UZBEKISTAN GAS TO LIQUID PROJECT (UZGTL)

HAZOP ACTION CLOSE-OUT REGISTER FOR MAKE-UP H2 COMPRESSOR PACKAGE

UZGTL-HDC-HSE-RP-50-0-0004

NOTES

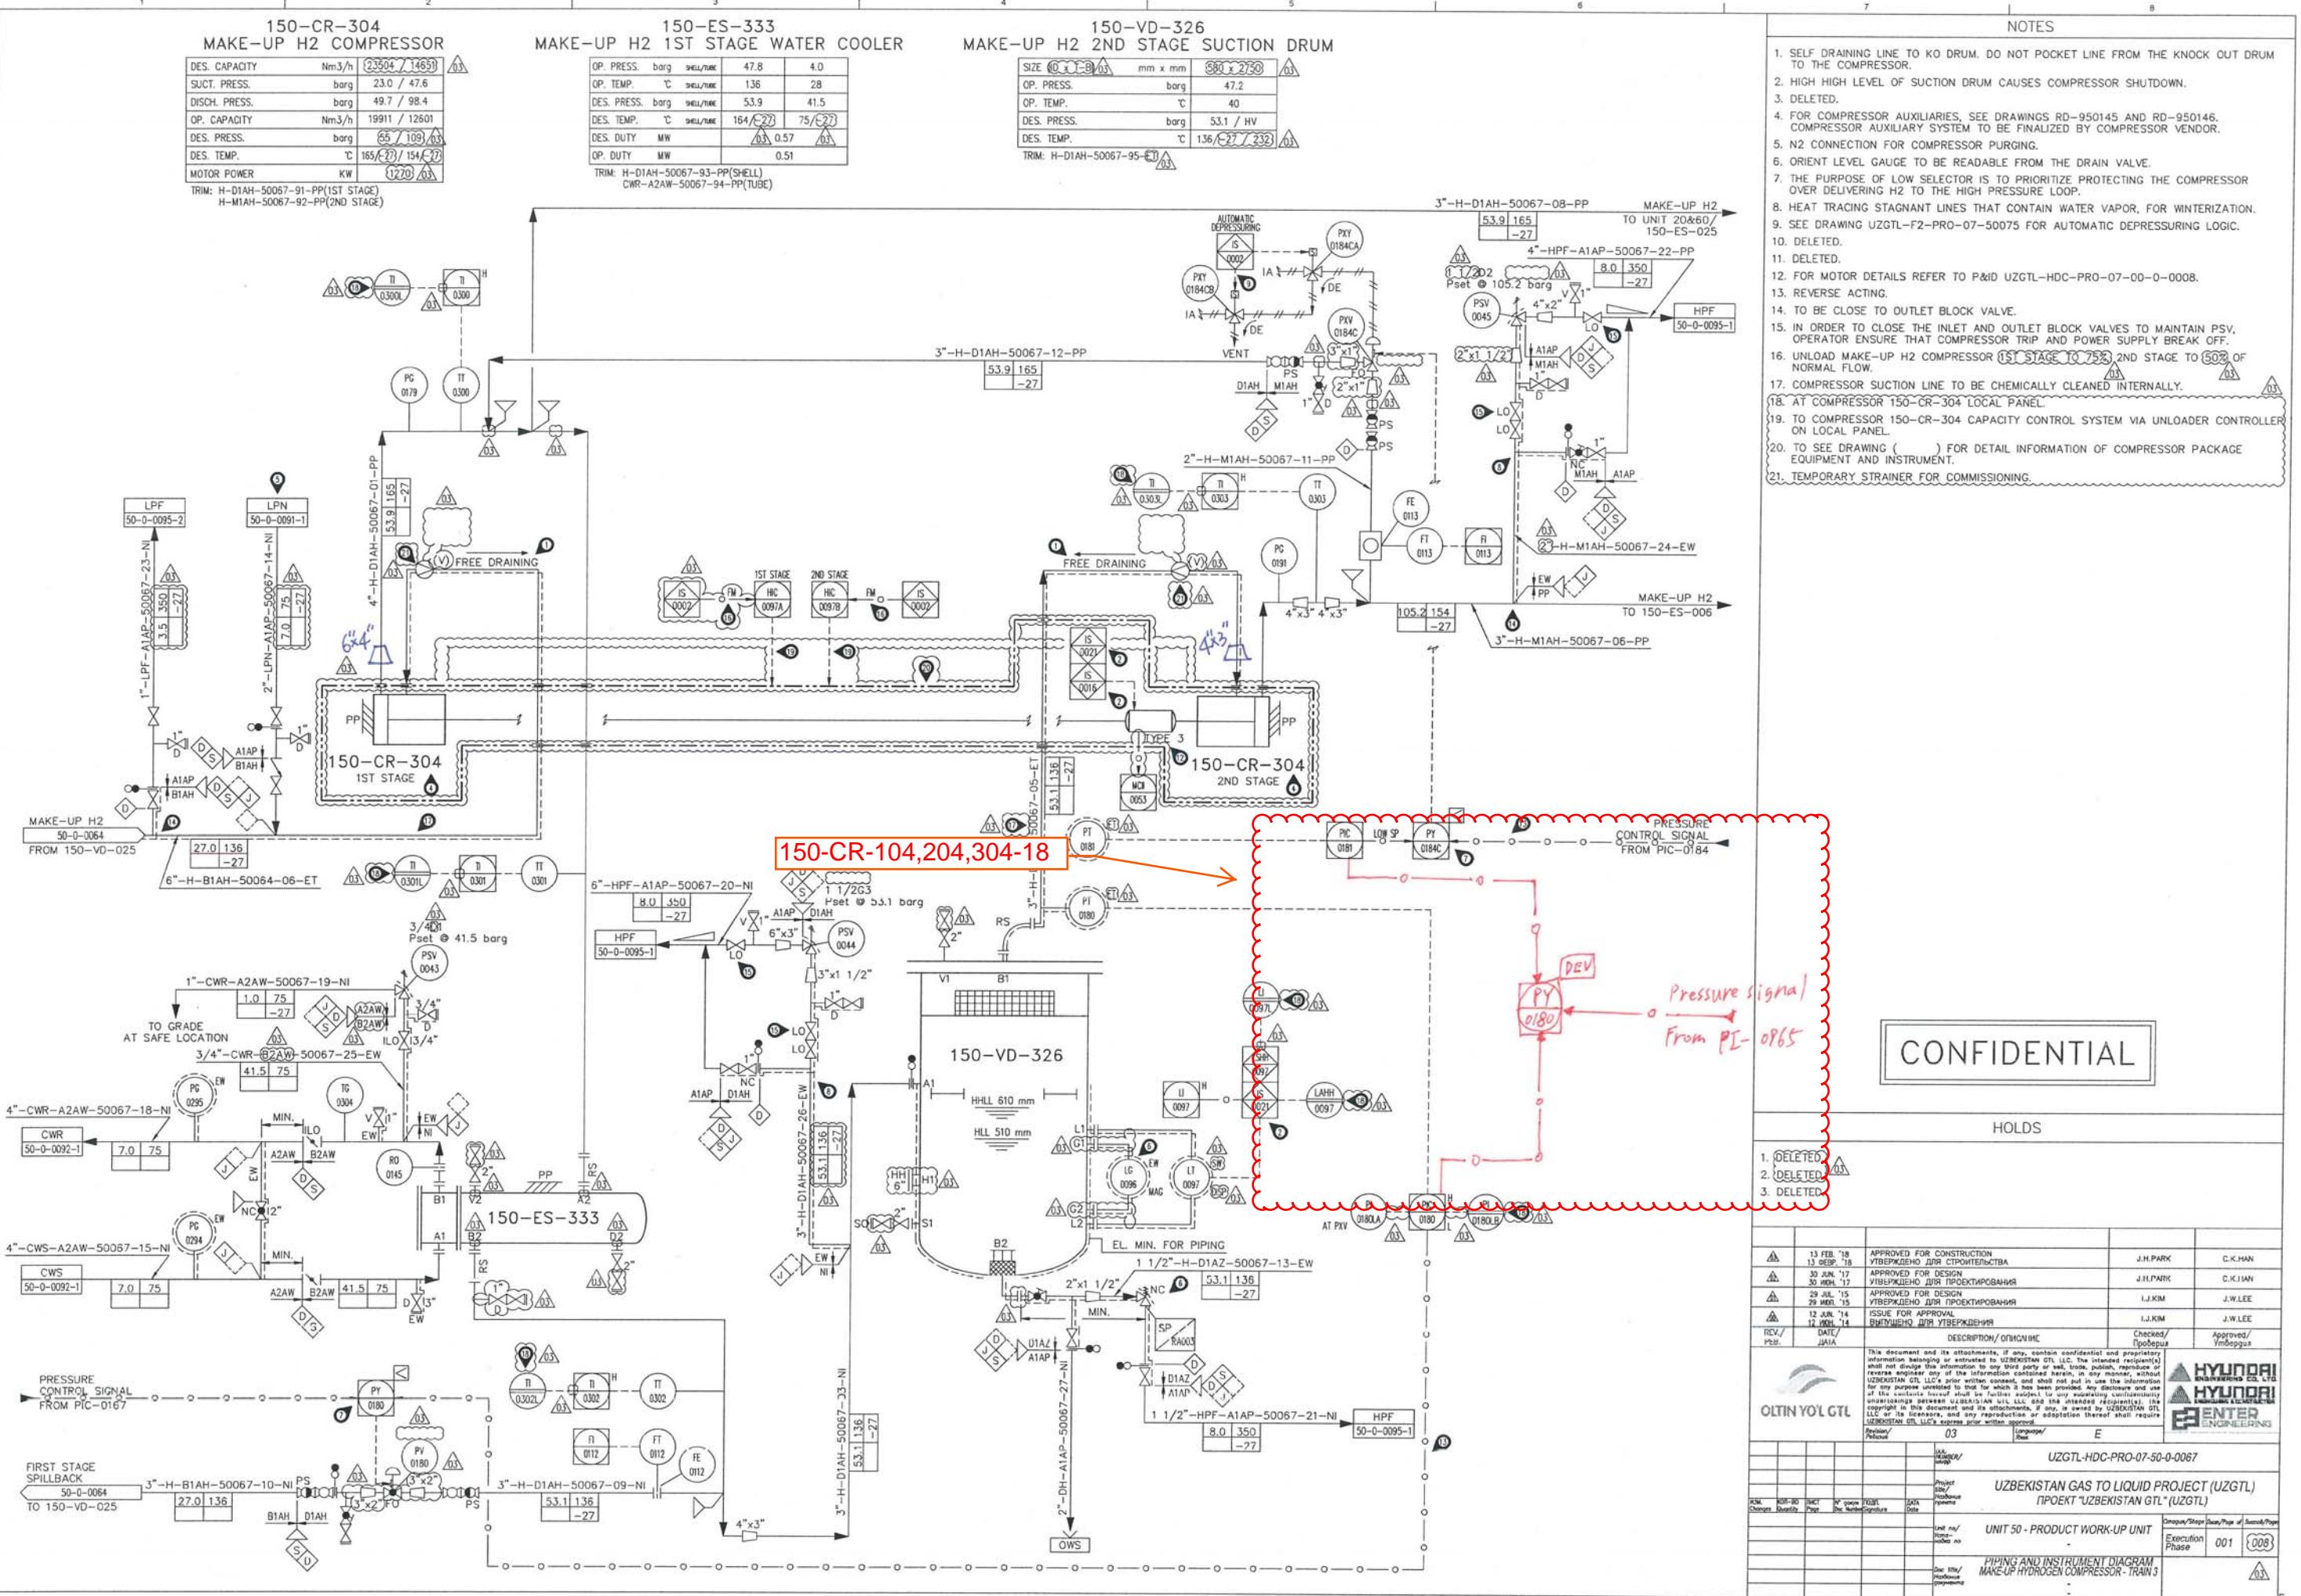
Action No.	150-CR-104/204/304-18	
Action By	PR	
Node No.	1	
Node Description	1. Compressor Process Gas / Compressor Vent & Drain / Compressor Unloader	
Cause	1.2.4. More Flow of process gas via H2 make-up line to Unit 20 / Unit 60 (Refer to Unit 50 Process HAZOP)	
Consequence	1.2.4.2. 2nd stage suction pressure decrease leading to compression ratio increase on 2nd stage resulting in mechanical damage of compressor. Increase of vibration.	
Safeguards	1.2.4.2.1. 150-PAL-0838A 1.2.4.2.2. 150-PSLL-0837A initiates 150-IS-0612 to trip Compressor (SIL rated) 1.2.4.2.3. 150-PDAH-0841A 1.2.4.2.4. 150-PDSHH-0842A initiates 150-IS-0612 to trip Compressor 1.2.4.2.5. 150-VAH-0831A (MMS) 1.2.4.2.6. 150-VSHH-0832A initiates MMS interlock to trip Compressor	
Action	Configure deviation alarm on DCS between 150-PT-0170, 150-PT-0171 and 150-PT-0838A

Response	Incorporated on P&ID (50-0-0065/66/67-1/2). Deviation alarm on DCS between 150-PT-0170, 150-PT-0171 and 150-PT-0838A will be provided. (Please refer to attached P&ID, UZGTL-HDC-PRO-07-50-0-0065/66/67-1/2)

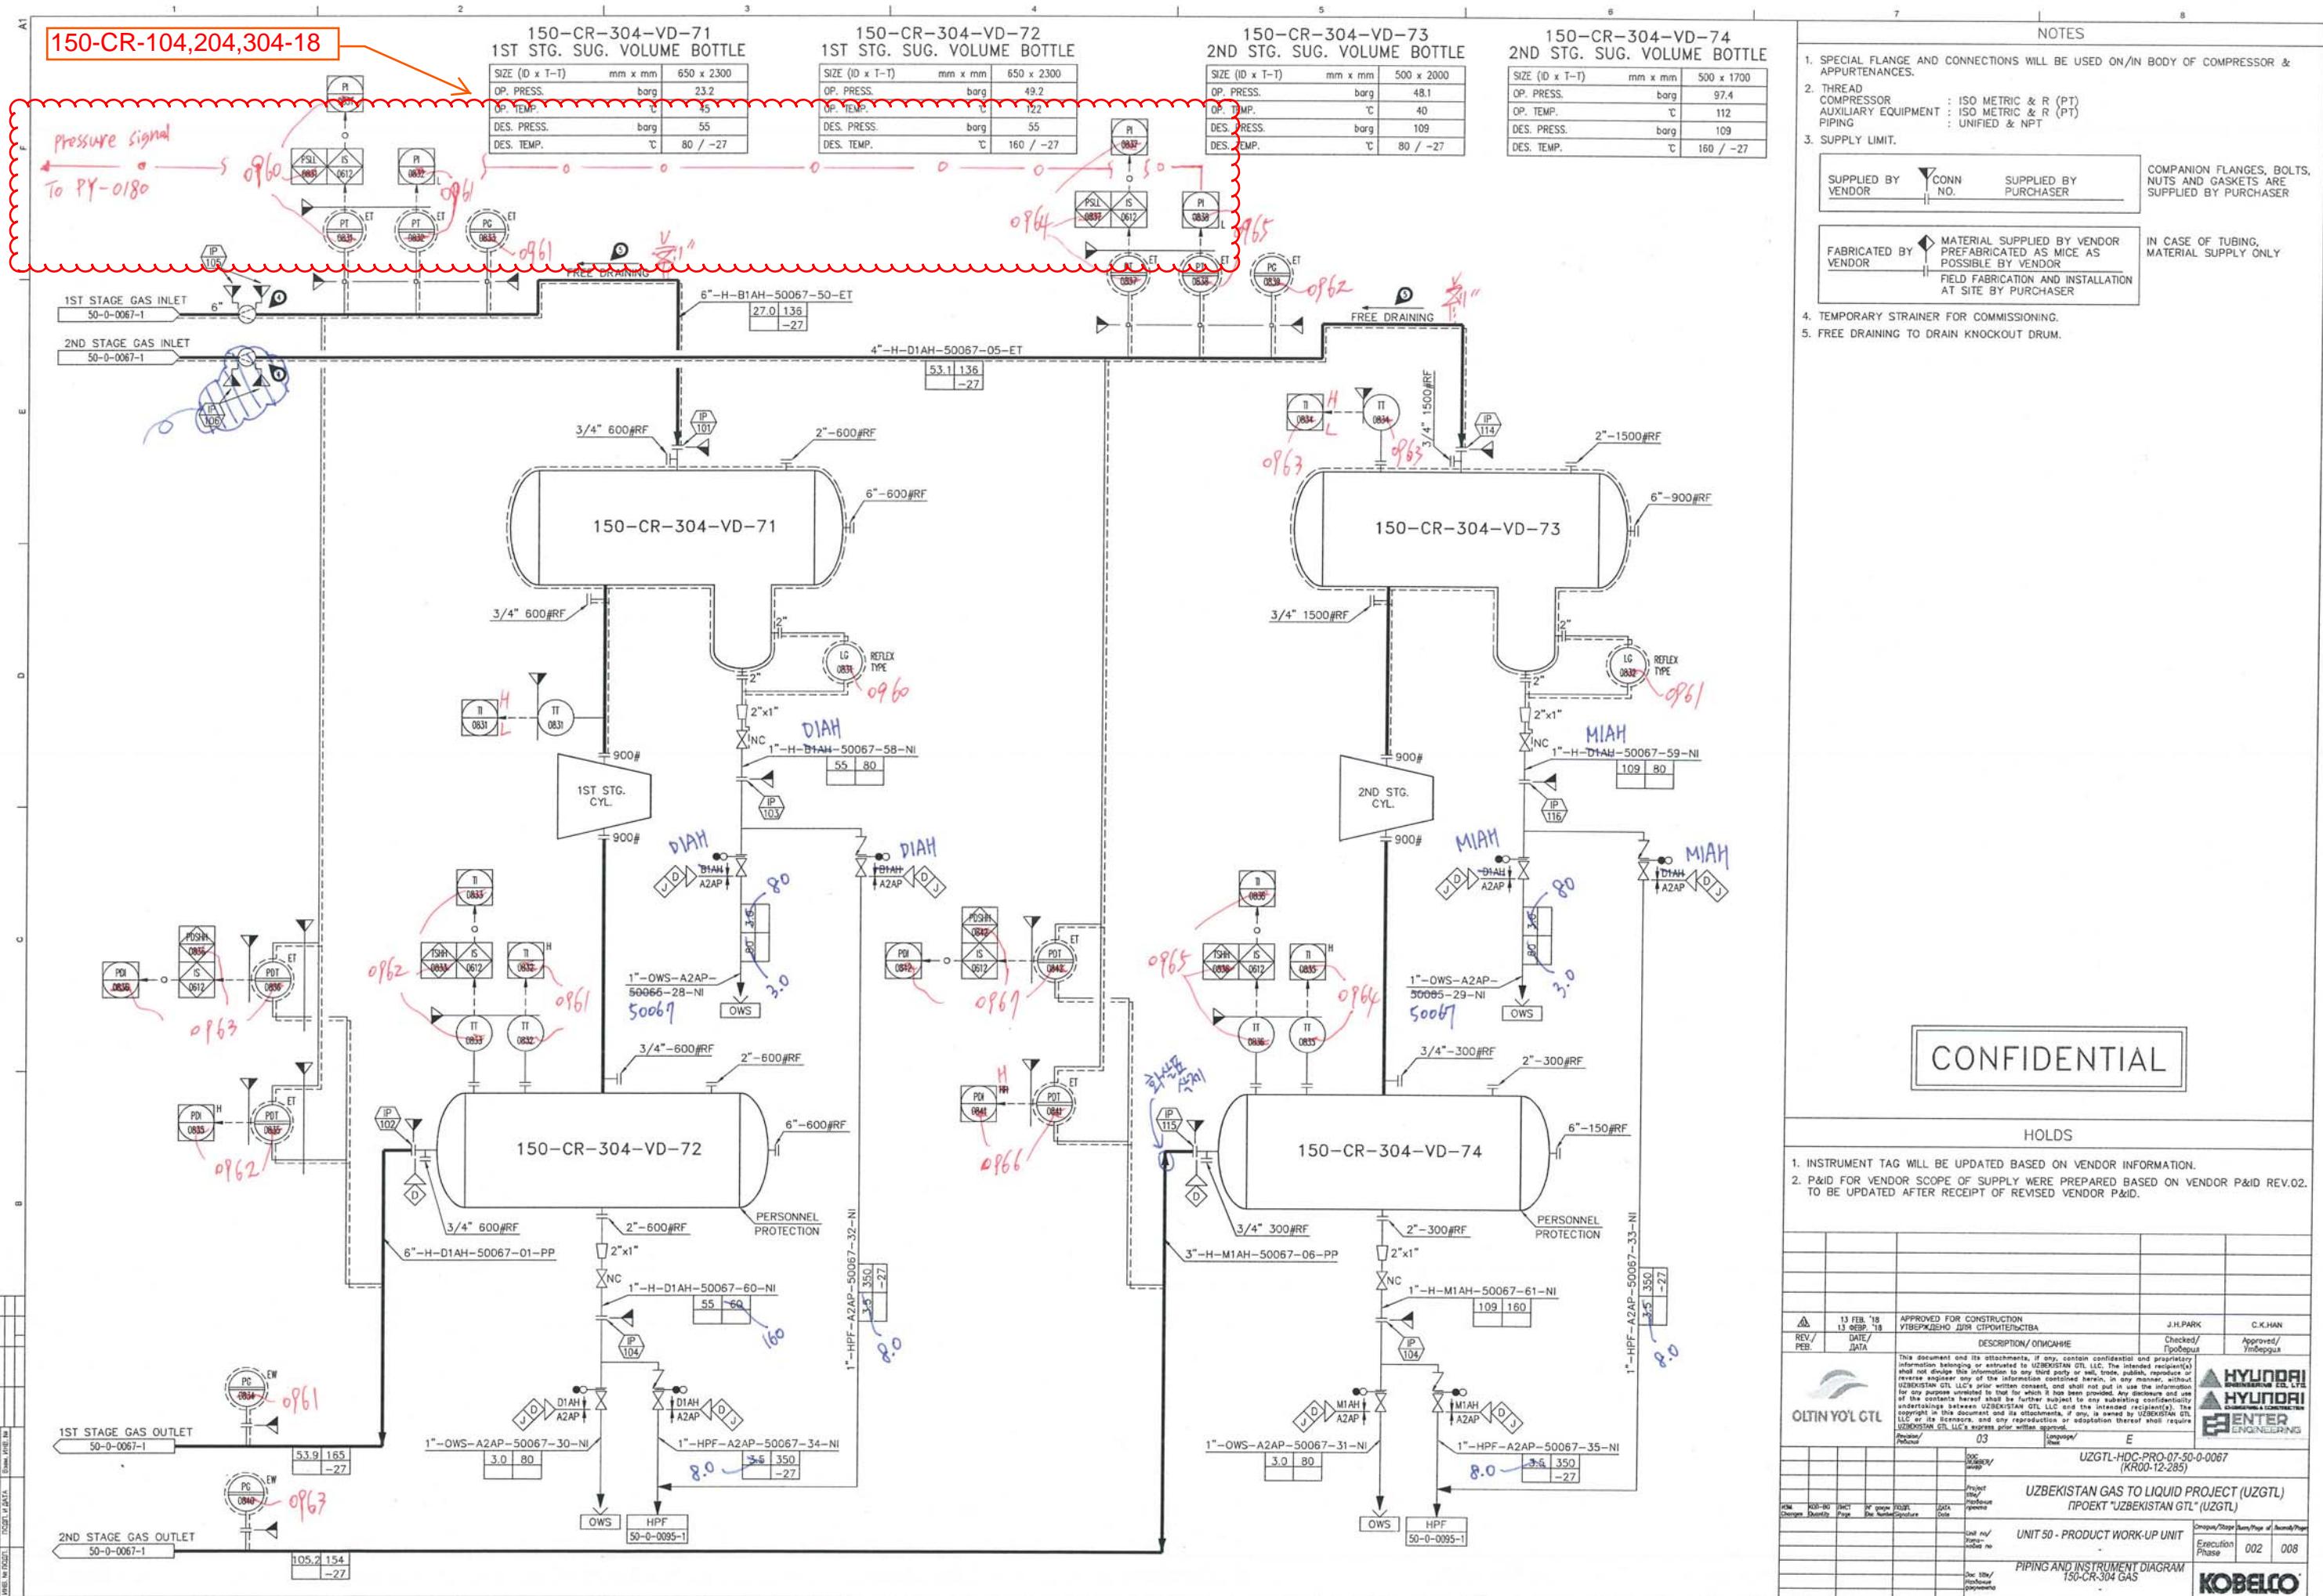
Action No.	150-CR-104/204/304-21				
Action By	PR				
Node No.	1				
Node Description	1. Compressor Process Gas / Compressor Vent & Drain / Compressor Unloader				
Cause	1.3.4. Reverse Flow of process gas from train 2 to train 1 due to train 1 Compressor trip (or vice versa)				
Consequence	1.3.4.1. Potential blow back of process gas into interstage section leading to potential overpressure				
Safeguards	1.3.4.1.1. PSV on 1st stage discharge (set at 53.1 barg) (Process side)				
Action	Provide check valve on 1st stage discharge of Compressor to Unit 20, 60, 50				
Response	Incorporated on P&ID (50-0-0068). Check valves are provided on 1st stage discharge of compressor. (Please refer to attached P&ID, UZGTL-HDC-PRO-07-50-0-0068)				
CONTRACTOR				OWNER	
Position	Signature	Date	Position	Signature	Date
Process Engineer	<u>B.M.Hwang</u> 	10-Apr-2018		_____
